TOM MYERS PRESENTATION ON BEHALF OF WHITE PINE COUNTY, GREAT BASIN WATER NETWORK, ET AL.

PRESENTATION TO THE OFFICE OF THE NEVADA STATE ENGINEER

SOUTHERN NEVADA WATER AUTHORITY

REMAND HEARING

Figure 21: Water budget accounting including storage change, ET/spring discharge (Q), and well pumpage for the Central Carbonate Flow System for the No Action alternative and Alternatives E and F, as simulated for the FEIS (FEIS Appendix F3.3.16).

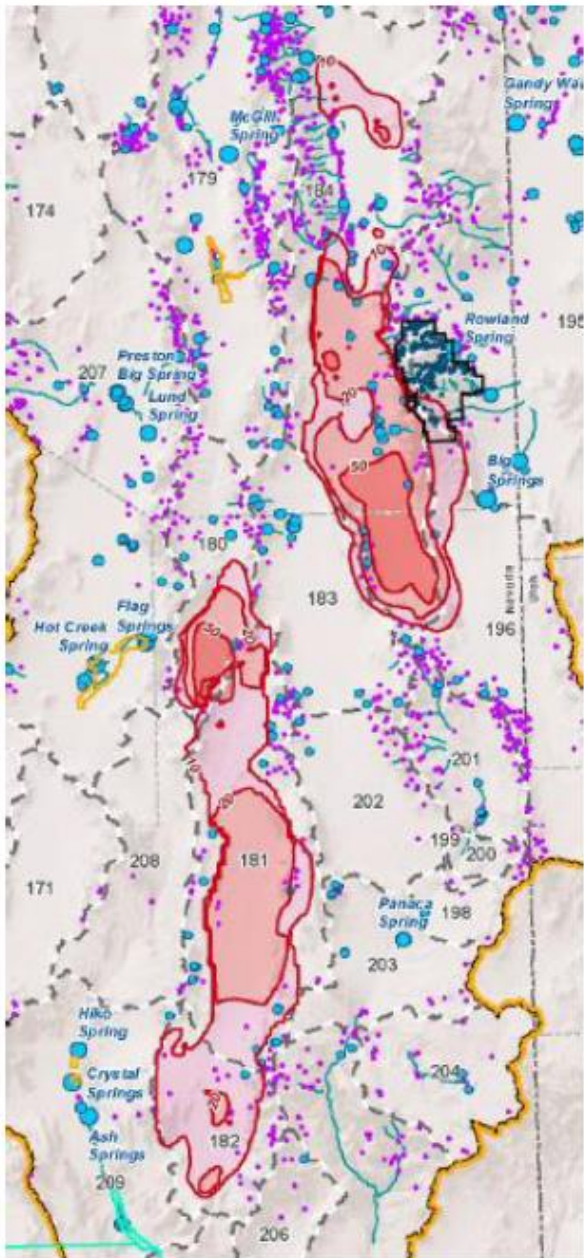
Alternatives E and F would increase the amounts removed from storage to near 85,000 af/y at full buildout in 2050. By the end of the simulation in 2250, amounts removed from storage were reduced to 51,900 and 68,500 af/y for alternatives E and F, respectively (Figure 21). The difference in captured storage between alternatives is mostly due to the difference in the amount of ET/Spring discharge captured (FEIS Appendix F3.3, Table F3.3.16-8B) with additional small amounts of change in the amount of interbasin flow to or from the CCFS that is captured or the amount of stream discharge captured. To the extent that storage changes or ET/spring discharge within the target basins pumped for Alternatives E or F, discussed below, do not explain the differences in Figure 21, the differences are due to changes in surrounding basins.

Figure 2: Figure 5-1 from Jones and Mayo (2017) showing the simulated flow budget for pumping SNWA's Ruling 6164 amount from SNWA's application points of diversion for 2000 years. Storage is groundwater storage, Drains is GWET, and Other sources was interbasin flow.

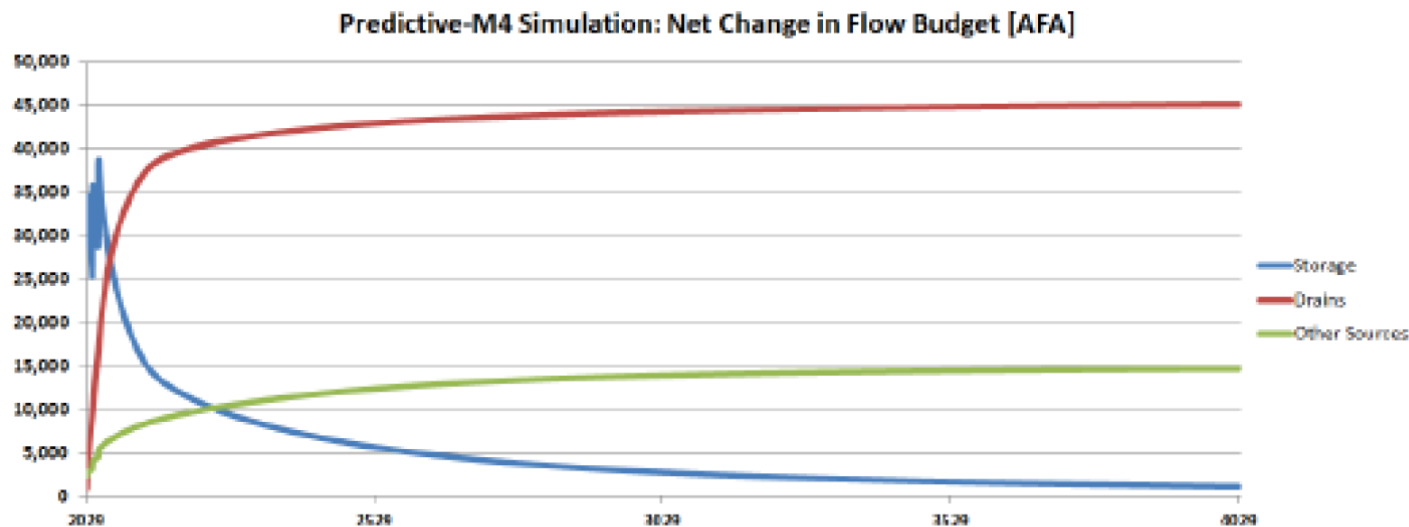
- Jones and Mayo's (2017) simulations demonstrate conclusively that pumping SNWA's applications would not be close to reaching equilibrium for 2000 years, and the project would capture flow from surrounding basins rather than from within Spring Valley.

This figure is especially telling. The storage should level out and reach a stable level as the system reaches a new equilibrium (as in Figure 3), but this system is not close to reaching a new equilibrium state after 2000 years of projected pumping. A plot of the predicted ET vs. time (Figure 8) shows that the system has not reached a new equilibrium in 2000 years.

Figure 29: Water budget accounting including storage change, ET/spring discharge (Q), and well pumpage for the White River Flow System for the No Action alternative and Alternatives E and F, as simulated for the FEIS (FEIS Appendix F3.3.16).

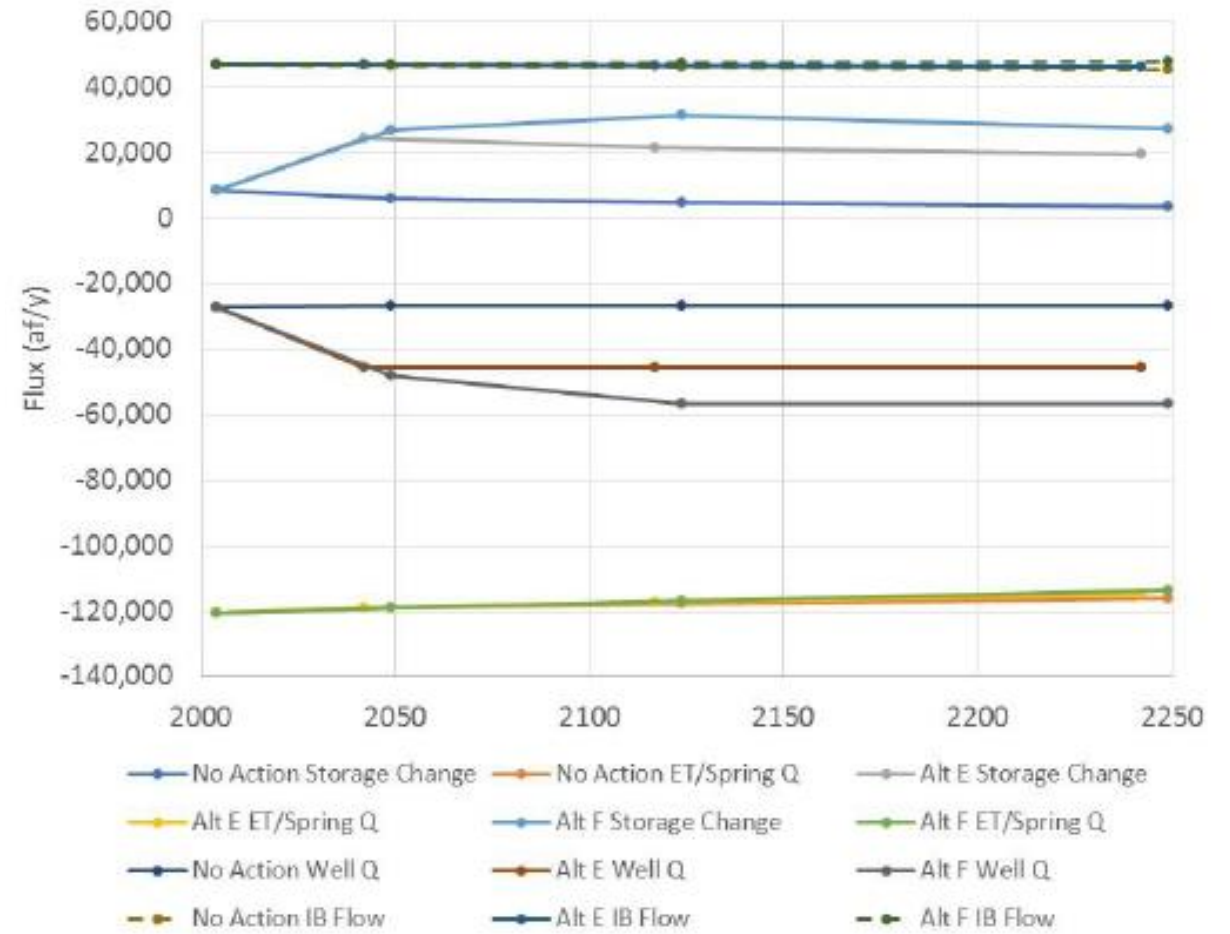
Pumpage from the WRFS for alternatives E and F, at 45,800 and 56,800 af/y at full build-out, respectively, including pre-existing pumpage (Figure 29), is a little less and a little more than 1/3rd of the recharge for the entire flow system, respectively. At full buildout, alternatives E and F remove 24,000 and 26,700 af/y, respectively, from the WRFS. And after 200 years pumpage still removes 19,400 and 27,100 af/y from storage for alternatives E and F, respectively (Figure 29). This means that 42% and 47%, respectively, of the amount of water being pumped is water that is being permanently removed from WRFS storage by year 2250. Two hundred years after full buildout, simulations show that a substantial amount of the pumpage is being removed from storage and that the system is not close to coming to equilibrium. The simulations further demonstrate that the removal of water from storage and attendant drawdown spreads outward across the flow system because of the connectivity among the basins in the WRFS.

Simulated recharge in Cave, Dry Lake, and Delamar Valleys is 15,400, 17,300, and 7500 af/y, respectively. Initially large portions of the pumpage draw from storage, and even 200 years after full buildout, pumpage for alternatives E and F are still removing 18% and 20% of pumpage from storage (Figure 29). After 75 years, the 10-ft drawdown for both alternatives

Figure 30: Water budget accounting including storage change, ET/spring discharge (Q), and well pumpage for Cave Valley for the No Action alternative and Alternatives E and F, as simulated for the FEIS (FEIS Appendix F3.3.16).

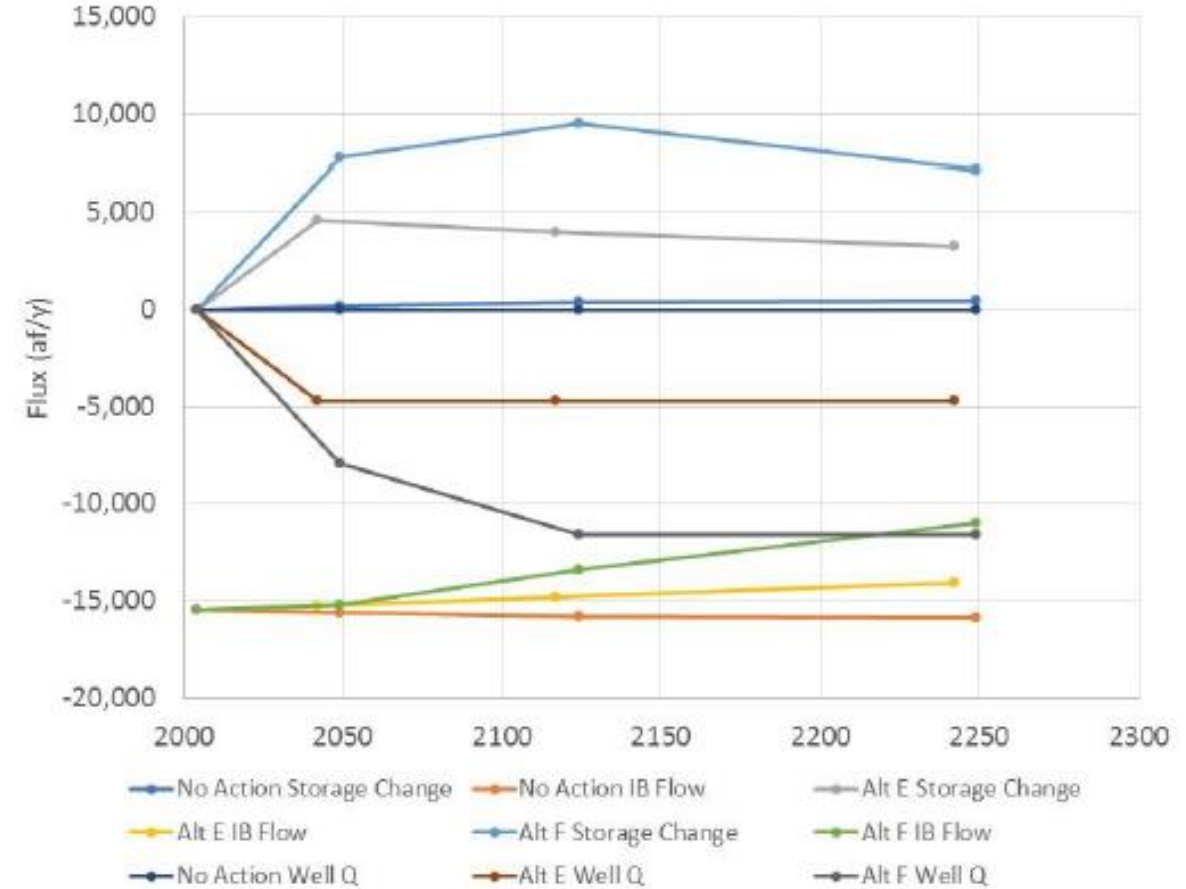
Most of the simulated Cave Valley recharge, 15,400 af/y, becomes interbasin flow and is about a third of the inflow to WRV (Figure 30). Alternatives E and F would pump 4700 and 11,600 af/y, respectively, at full buildout. By 200 years after full buildout, interbasin flow leaving Cave Valley has decreased by about half of the pumpage amount, meaning that after 2250 there still will be a very long period during which SNWA's pumpage in Cave Valley would continue to eliminate interbasin flow to downgradient valleys. The interbasin flow decrease would continue until it finally has eliminated all such interbasin flow permanently (Figure 30). Continued lowering of the water table reflects that much of the pumpage is removed from storage within Cave Valley. By 2250, simulated pumping draws the water table down about 100 and 250 feet for Alternatives E and F, respectively (Figures 23, 25, and 31). The water surface elevation graph in 2250 slopes downward at a constant rate indicating continued linear drawdown would occur well beyond 2250 (Figure 31).

Figure 13: Portion of Figure 1-1 from SNWA (2017b) showing SNWA's plan for monitoring in Spring Valley and surrounding valleys.

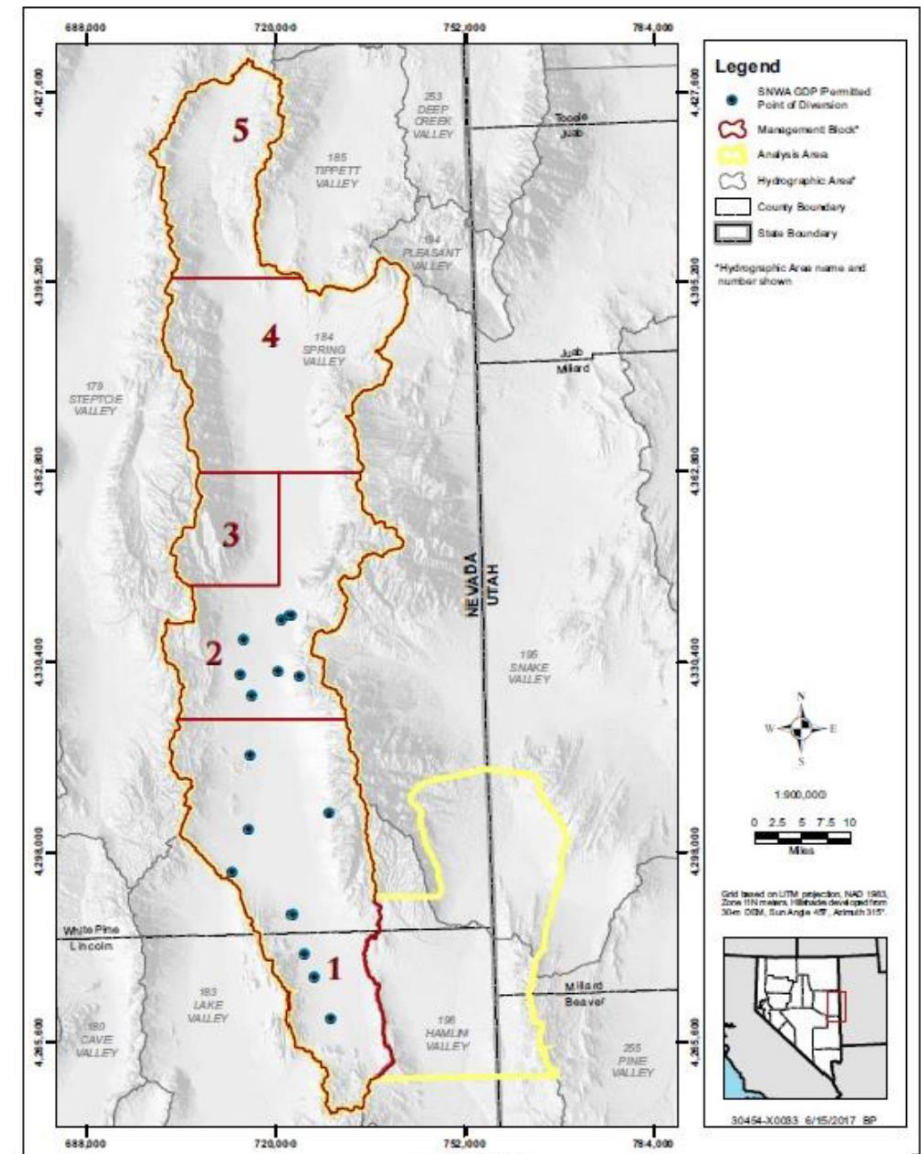
Outside of Spring Valley, SNWA's proposed 3M plan includes **only part of northern Hamlin Valley and southern Snake Valley near Big Springs (Figure 13).** It does **not include Tippett or Pleasant Valley or consider any potential for the project to affect Gandy Warm Springs,** meaning the SNWA monitoring plan does not consider interbasin connections found in BARCASS (Welch et al. 2008) and even SNWA's own modeling (Myers 2017).

Figure 14: Figure 2-1 from SNWA (2017b) showing the location of proposed monitoring for Spring Valley.

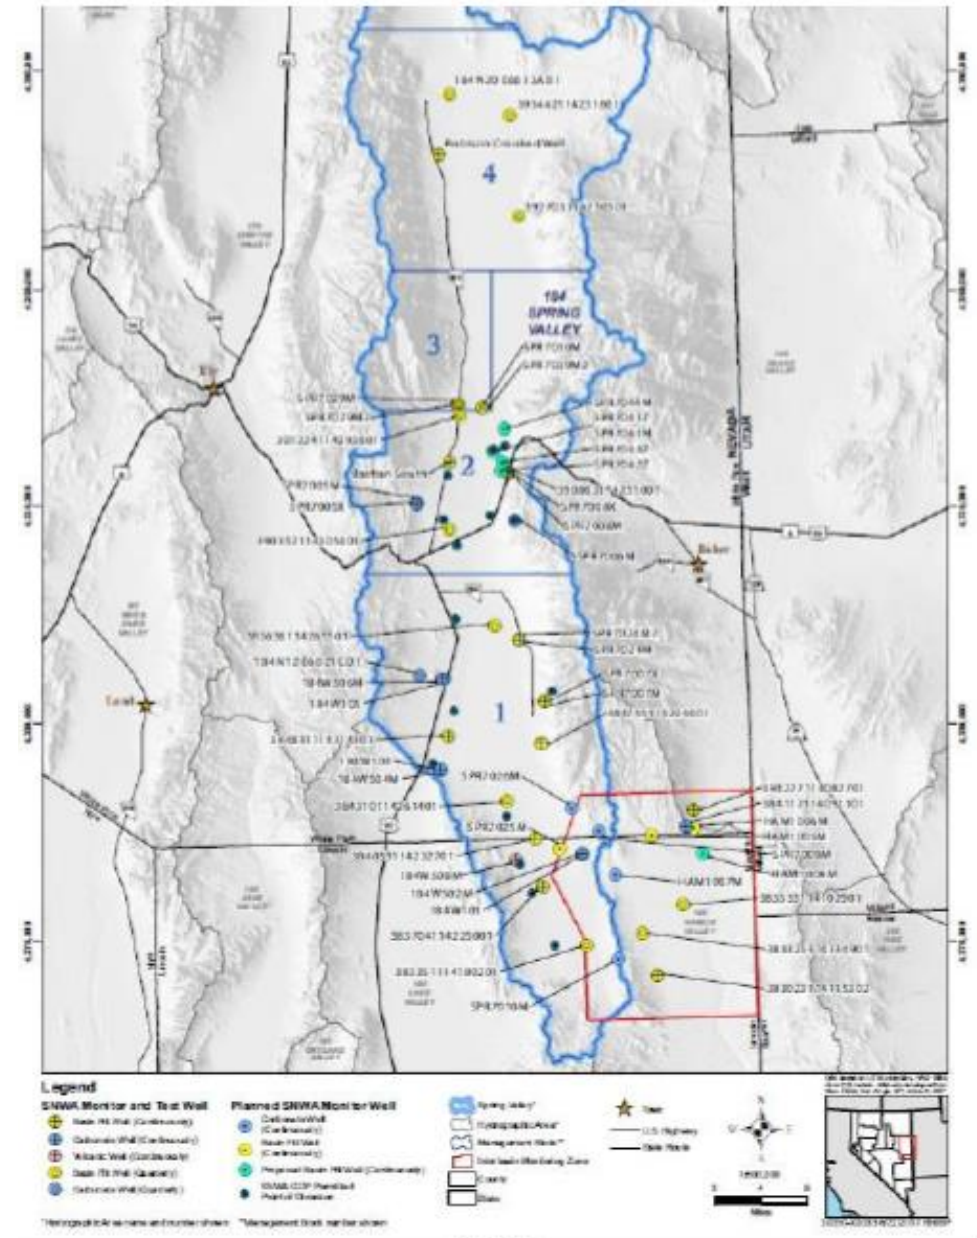
SNWA (2017b) Table 2-1 lists all the monitoring sites proposed for Spring Valley and Figure 2-1 (reproduced here as Figure 14) shows them. There is much less to that table than is apparent by simply considering its length, five pages long. There has been little added to it since 2011, the plan of which was reviewed by Myers (2017). Management area 1 would have 29 monitoring locations, many of which are already installed and several of which are simply spring flow monitoring or shallow piezometers. This is for an area that is about 30 by 10 miles. Management area 2 would have 26 monitoring locations, including several spring flow sites and piezometers. These also include as two locations various paired monitoring wells, such as SPR7005X and M or SPR7008X and M. This is for an area about 20 by 10 miles. Very little monitoring would occur north of the Cleveland Ranch which has only the sentinel wells and a spring proposed for Management Area 3 (Figure 14).

Figure 15: Portion of Figure 2-8 (SNWA 2017b) showing the SNWA PODs and proposed monitoring for the Cleveland Ranch/McCoy Creek Area.

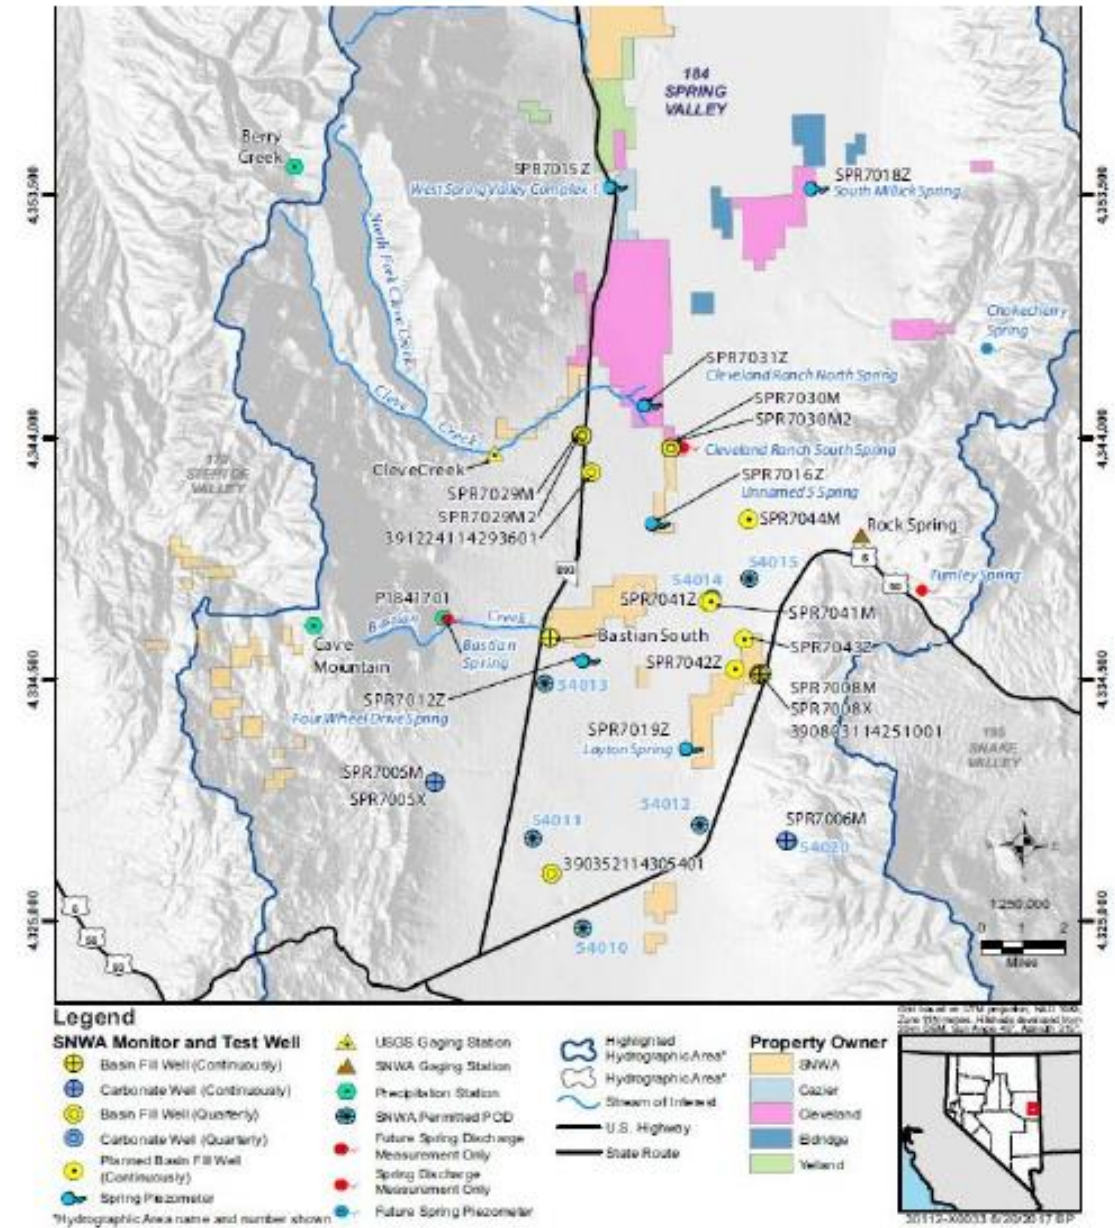
Figure 15 shows most monitoring proposed for Management unit 2, which lies south of the Cleveland Ranch (Figure 13). The sentinel wells just described would also be responsible for monitoring at least ten additional water rights, not on the Cleveland Ranch (Table 2-4, SNWA 2017b). Monitor well SPR7044M is an additional monitor well southeast of the Cleveland Ranch. (Id.) Piezometer SPR7012Z and SPR7016Z would monitor about 15 additional water rights. (Id.) **At least eleven water rights would be monitored only at the right's POD.** (Id.) Wells SPR7041M and Z, and piezometers SPR7042Z and SPR7043Z would monitor the Swamp Cedar area. (Id.) The monitoring near the Swamp Cedars area is intended to be related to the conditions of the area, such as tree density and health, rather than provide a trigger for management and mitigation (SNWA 2017b, p 2-51). As can be seen on Figure 15, these are the sole wells available for monitoring an area of about twelve by 24 miles, which is inadequate on its face.

Management Block 3, the Cleveland Ranch, would have five sentinel monitor wells near the southern end of Cleveland Ranch, as described on page 2-25 of SNWA (2017b) and shown in Figure 15. SNWA would monitor only three locations with these five wells because two locations include paired wells screened at different depths. These would be the northernmost monitoring wells and would be the sole monitoring points to detect drawdown signals for management areas 4 and 5. **These three monitored locations are grossly insufficient because they are spread too far and would monitor aquifer layers that are much too thick to adequately**

Figure 20: Portion of SNWA (2017a) Figure 2-4 showing springs, monitoring points, and points of diversion in White River Valley, Cave Valley, and Dry Lake Valley.

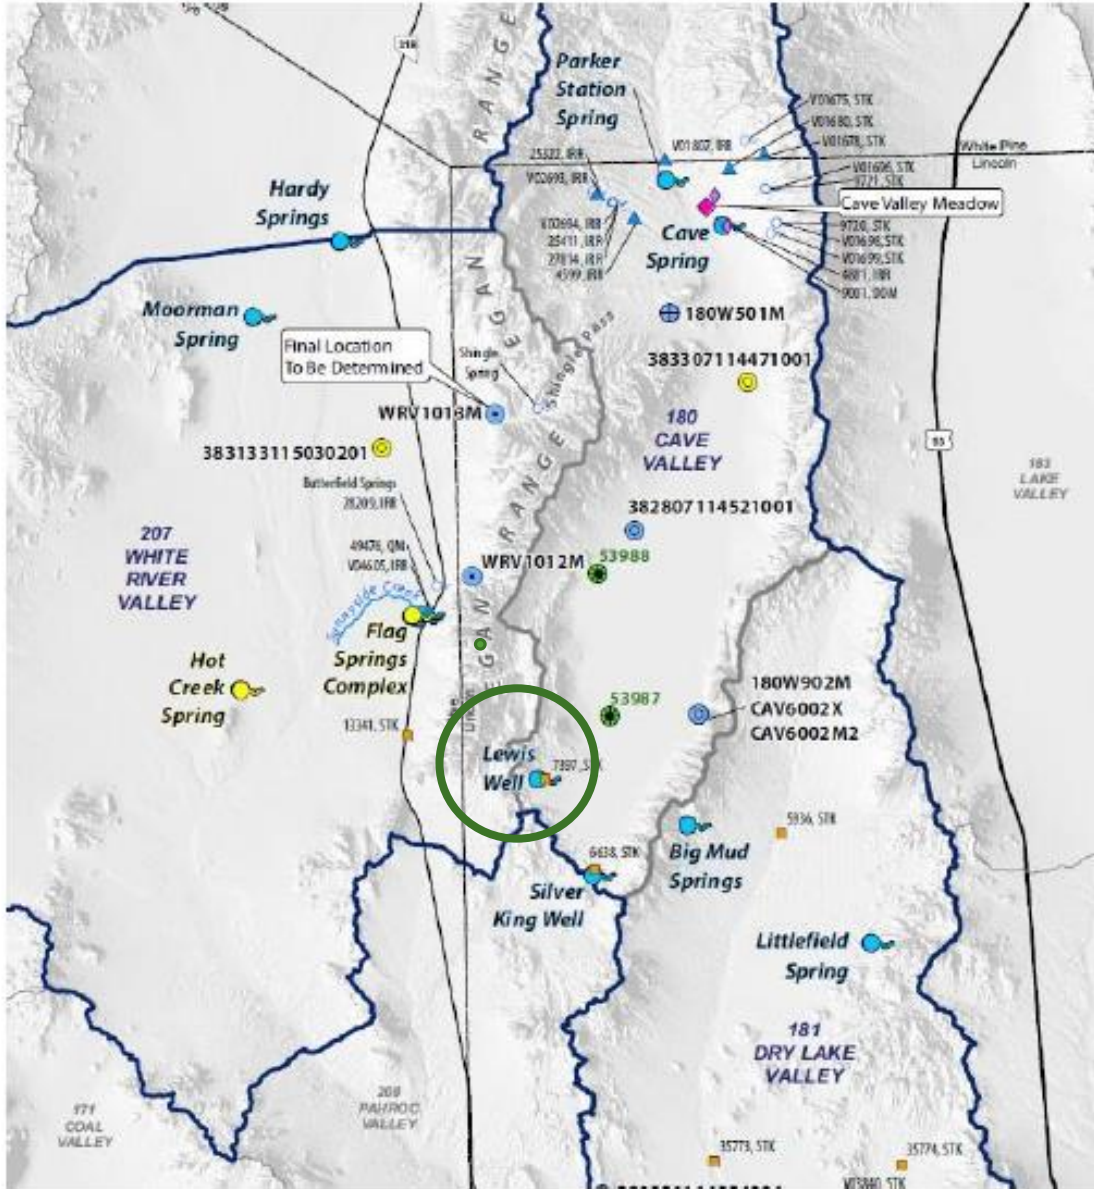
The 3M regime for southern WRV includes four sentinel wells and spring flow monitoring at Flag Springs and Butterfield Springs (Marshall et al. 2017, p 8-19). Four sentinel monitor wells assessing impacts on flows between Cave and White River Valley, existing wells 383307114471001 and 180W501M and proposed wells WRV1013M and WRV1012M (Figure 20), is grossly insufficient, as critiqued in Myers (2017). SNWA claims the "stratigraphy and structural orientation of the Egan Range makes it very unlikely for groundwater flow to occur directly across the range west to Flag Spring from Cave Valley" (SNWA 2017a, p 2-17), but this is an overly broad statement that conflicts with other documentation of the likely flow between the valleys (Welch et al. 2008, SNWA 2011a). Marshall et al. (2017) acknowledges that there is flow through Shingle Pass, but suggests that Cave Valley flow probably does not contribute directly to the warm springs but likely does contribute to the cool, range-front springs including Butterfield and Flag Springs (Marshall et al. 2017, p 8-14).
